3,500 lb. Capacity

## HOISTWAY PLAN

SHEET A9.0a

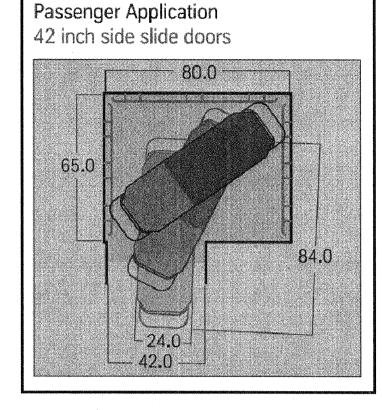
PLEASE VERIFY WALL THICKNESS

VERIFY HOISTWAY DIMENSIONS WITH MANUFACTURE PRIOR TO POURING ELEVATOR PIT

ELEVATOR 2 TO BE ON BATTERY BACKUP

PROVIDE VANDAL RESISTANT FIXTURES FOR BOTH THE CAR CONTROLS AND HALL STATION ON ALL FLOORS
